ENVIRONMENTAL ASSESSMENT REPORT

Gundagai Quarry Expansion

DTK Logging Pty Ltd

Board of the Environment Protection Authority

Figure 4: Nearest residences (Figure 4-4-5 of the DPEMP)

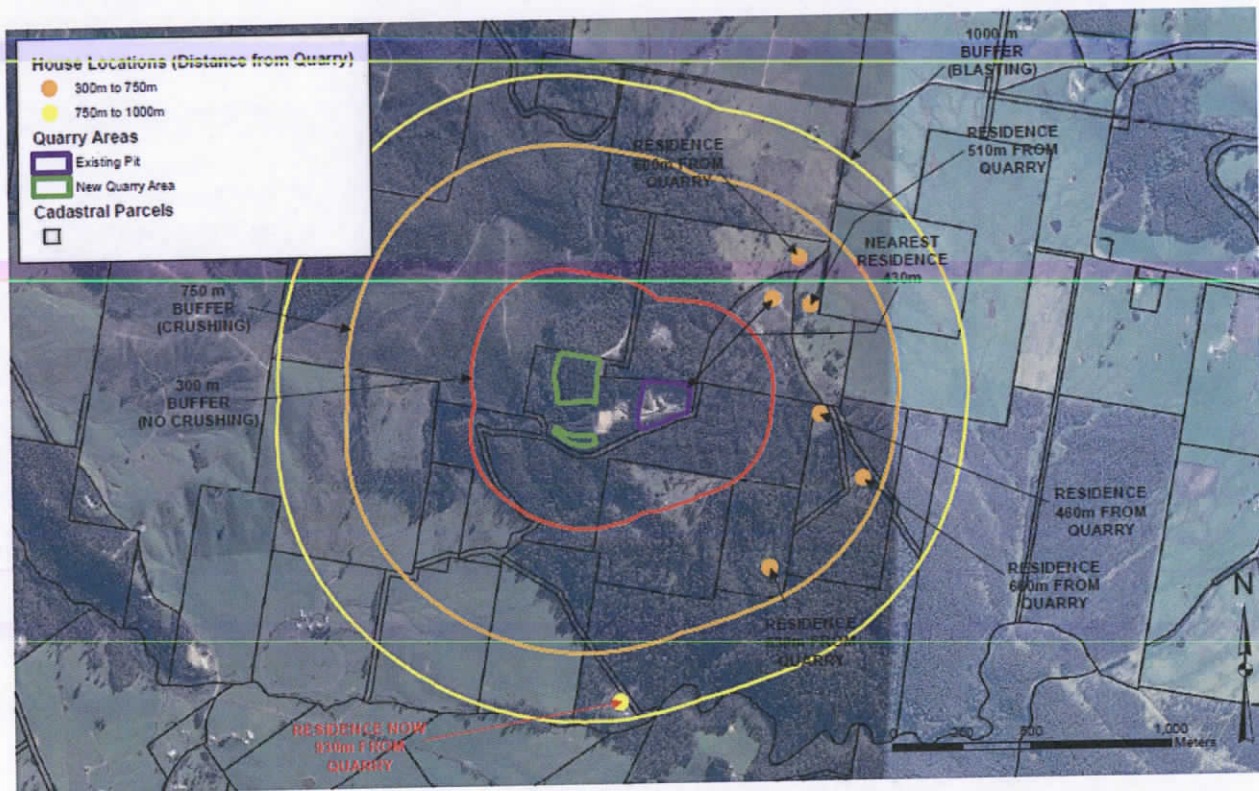
According to the DPEMP, the topography between the existing pit and the nearest residences (430 m and 460 m away, Figure 4), is relatively flat, with the existing pit being below the natural surface. Most of the noise from machinery within the existing pit (e.g. the crusher and screening equipment) is currently deflected by the eastern quarry face, which acts as a topographical buffer for the residences to the east.

Figure 6 Distance to nearest residences from the initial quarrying location within the NW extraction area (Figure 4-4-6a of DPEMP)

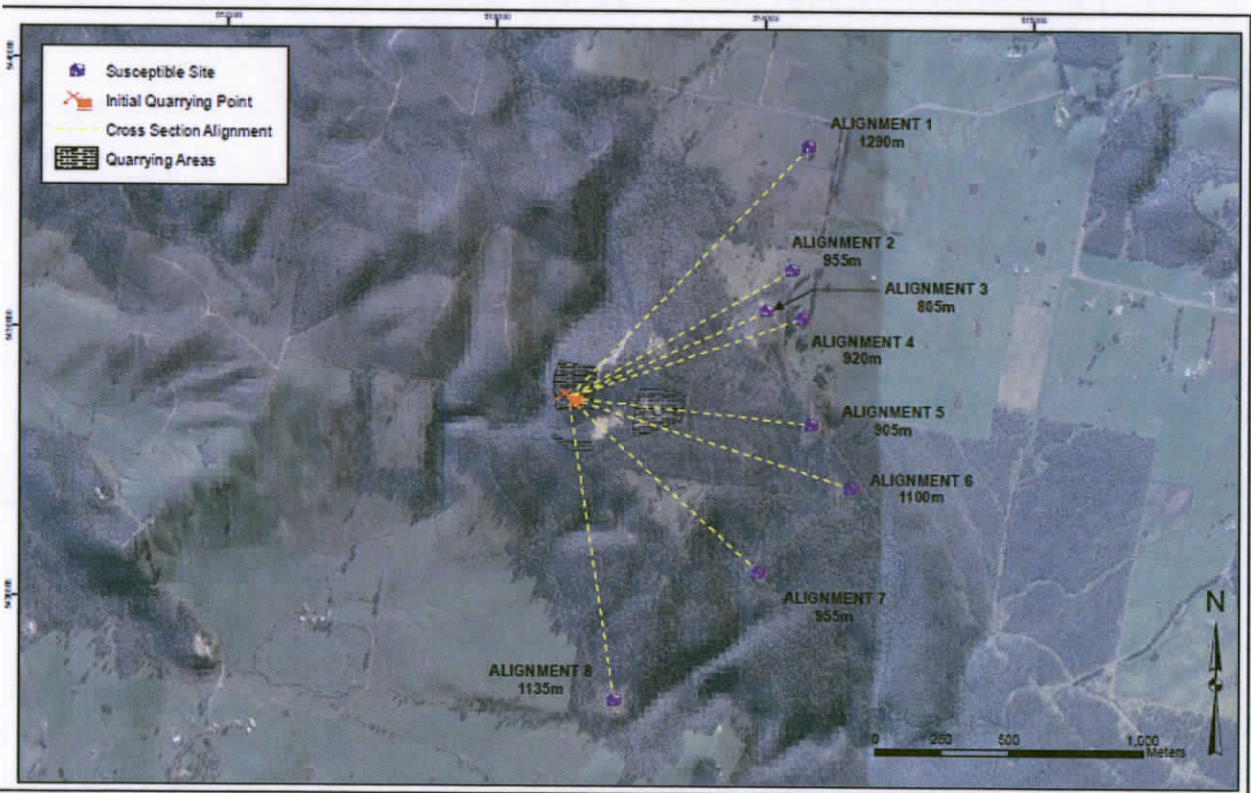
Noise levels are predicted to be 49.5 dB(A) L_{Aeq} at the nearest residence, 805 m away from the initial quarrying point in the NW quarry area (alignment 3 in Figure 6).

According to the DPEMP, all residences to the east will be topographically shielded from this location (e.g. Figure 7, with all topographical cross sections shown in Figures 4-4-6b to 4-4-6i of the DPEMP).

The proponent considers the effect of the topography will be to reduce the estimated drill rig noise to less than 46 dB(A) at the nearest residence.

Figure 7 Topography between the initial quarry point in the NW area and the closest residence (alignment 3 in Figure 6) (Figure 4-4-6d of the DPEMP) (X-axis units are AHD metres).

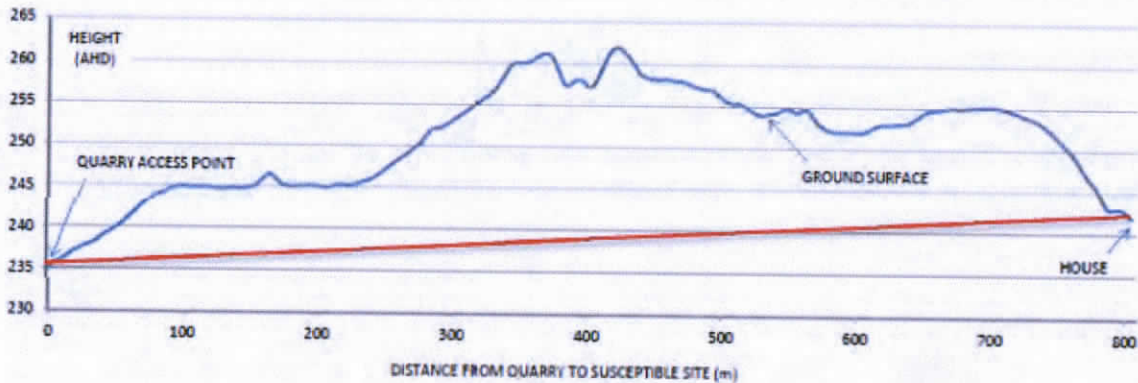
The DPEMP concluded that there is also topographic shielding between the high point in the NW quarry area and the residences to the east, considered a 'worst case' location in terms of height (at approximately 250 m AHD) and distance (685 metres to the nearest residence, alignment 11 in Figure 5). Topographical cross sections are shown in Figures 4-4-7b to 4-4-7i of the DPEMP.

The DPEMP did not provide an estimate of the noise levels at the nearest residence from drilling at this 'worst case' location, stating that the drill rig will not be sited here.

Figure 8 Cross-section of quarry extraction plan for the existing pit (Figure 2-2-4b of the DPEMP).

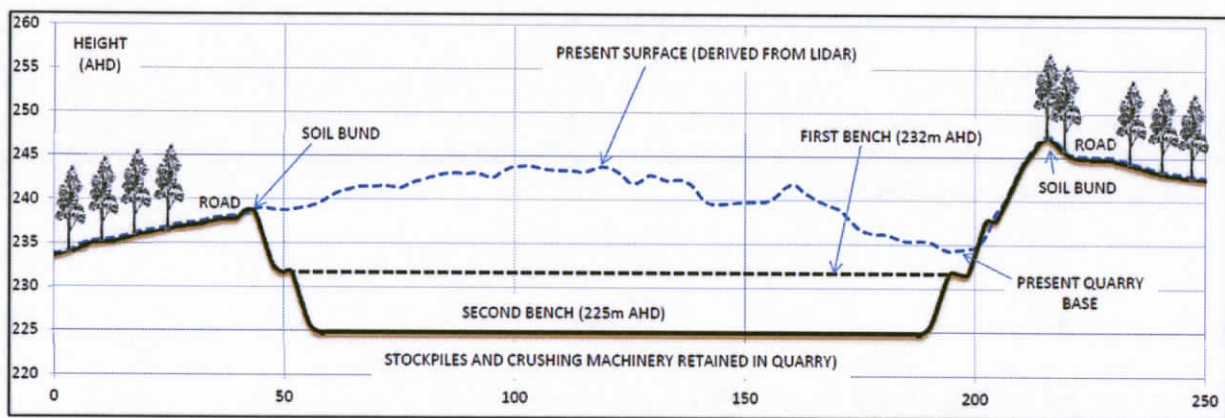
Assuming the same drill rig is used, noise levels may be exceeded by as much as 7 to 8 dB(A) if drilling were to occur on the present surface (e.g. above 240 m AHD, Figure 8), away from the shielding effects of the eastern quarry face.

It is noted that a 'first' bench will also be created at 232 m AHD. Sufficient information has not been provided in the DPEMP to determine whether drilling at this height, particularly away from the eastern quarry face, will comply with the daytime limit.

To reduce the risk that drilling in the existing pit creates a noise nuisance, the proposal to use a shrouded drill rig at the quarry, or similar, is required by condition **N5**. The options proposed in the DPEMP to mitigate drill noise are considered appropriate. A transmission loss of up to 10 to 15 dB is considered possible.

Figure 9 Quarry plan, NW extraction area (Figure 2-2-5a of DPEMP)

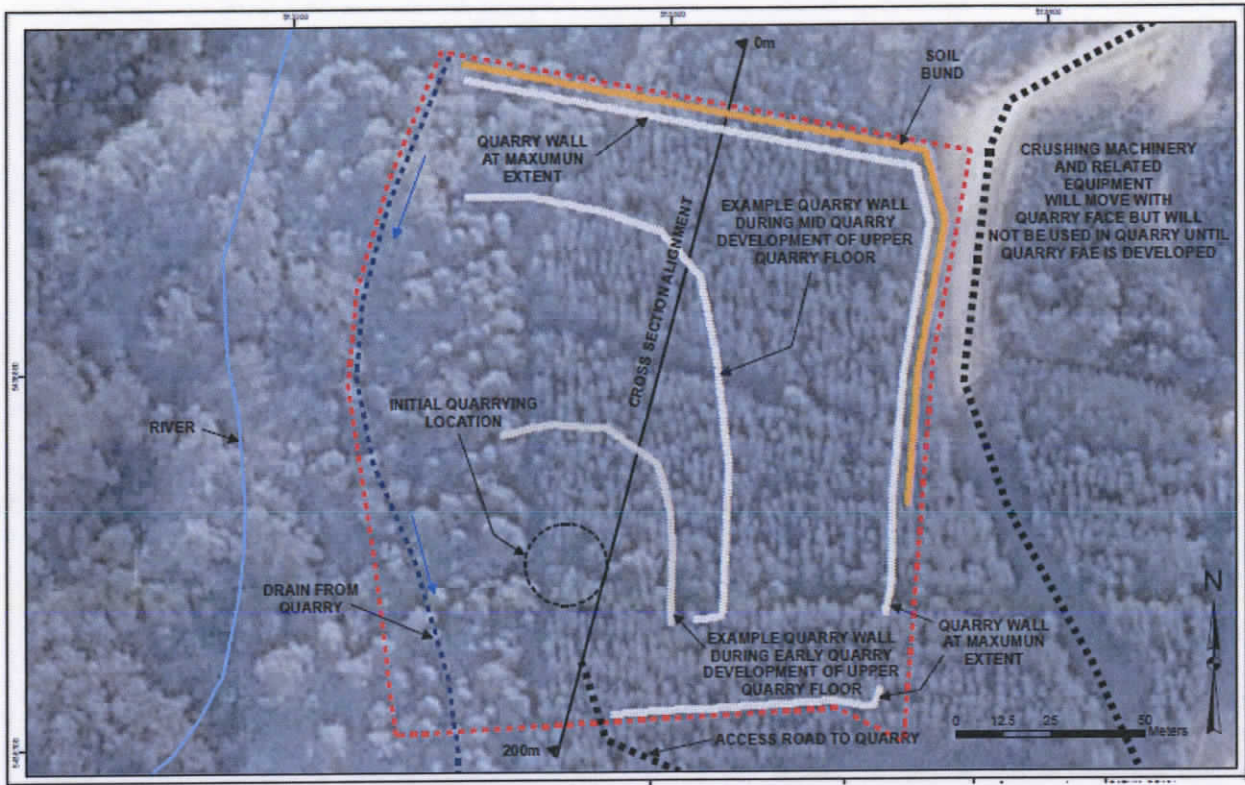
Further, as the NW pit is developed north-eastwards (see Figure 9), the drill rig may be positioned closer to the residences than the initial quarrying point.

Figure 11 Cross-section of quarry extraction plan for the SW extraction area (Figure 2-2-6b of the DPEMP).

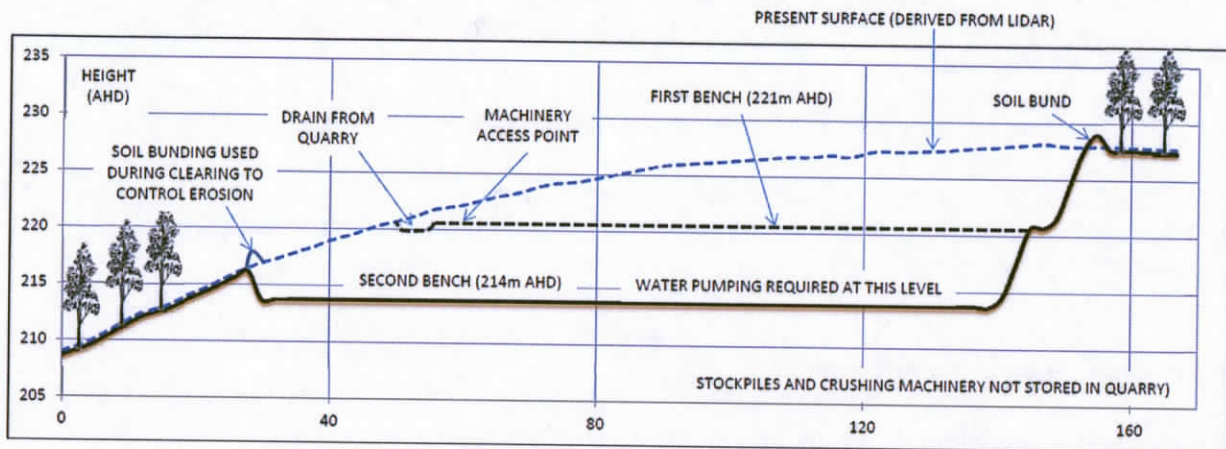
The SW pit however will be developed to a second bench at 214 m AHD, necessitating the pumping of water from the pit once it reaches a depth where water will no longer flow to the lower sediment dam. According to the DPEMP, soil bunding (e.g. as shown in Figure 10), will be used to direct water flow into the drain feeding the dam.

The DPEMP supplement indicated that the cross sections provided in the DPEMP (e.g. Figure 11) are likely to be subject to further review. As the first bench of the SW pit is unlikely to be fully developed until after 2020, condition **G8** (Environmental Management Plan) will capture any changes to the quarry plan, with subsequent review of the stormwater management system.

Figure 12 Access Road (Easement 14091) (Figure supplied by Forestry Tasmania)

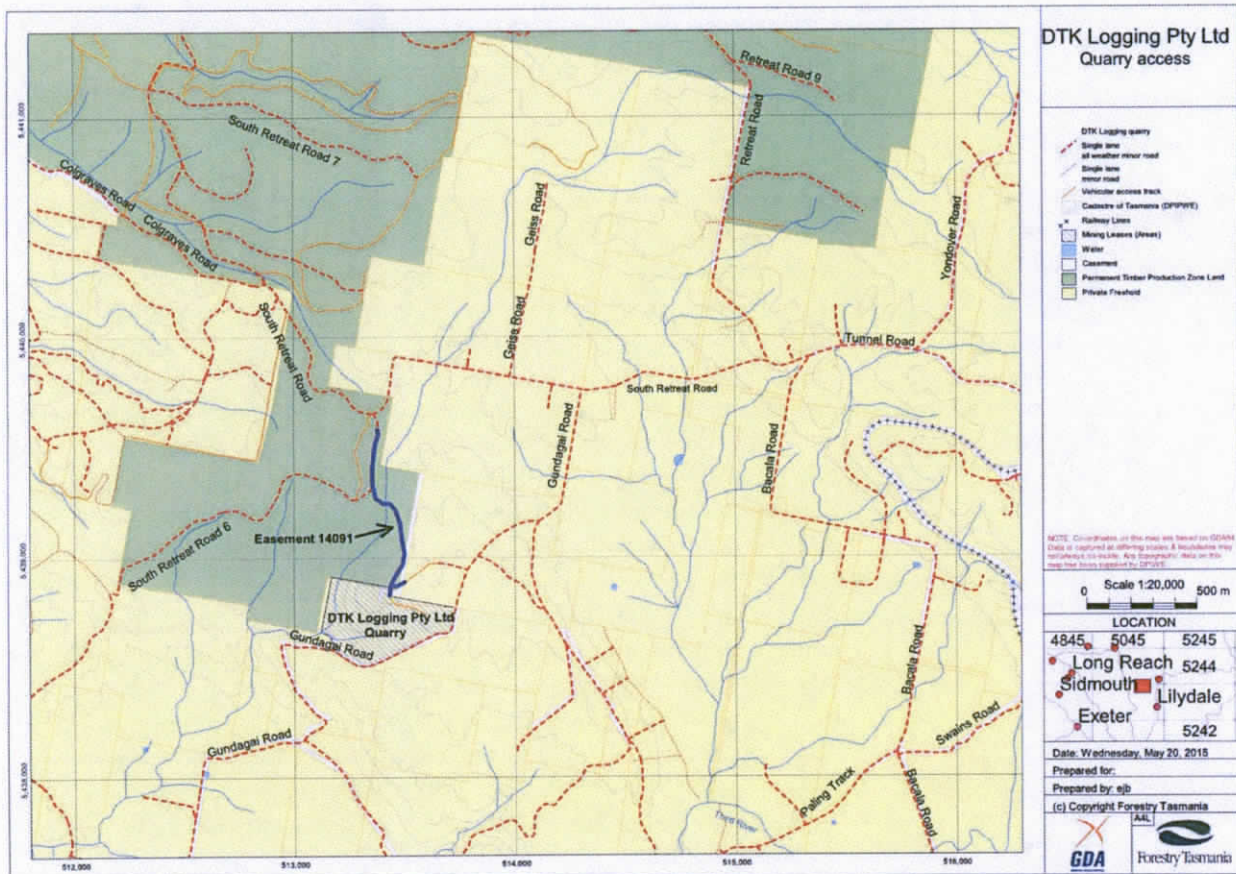
They did not however specifically address the potential for increased traffic during night-time hours (as defined above) on the quarry access road (see Figure 12, Issue 8).

Notwithstanding, given the lack of evidence of habitat use by threatened species within the mining lease (2010 and 2014 ecological surveys), with no records of occurrence within a kilometre of the quarry (see Figure 4-7-2 of the DPMP), it is considered that the proposal is unlikely to represent a significant increase in the risk of roadkill of threatened species. Furthermore, the nature of the access road is such that trucks are unlikely to travel at high speeds, thus partly mitigating roadkill risk.
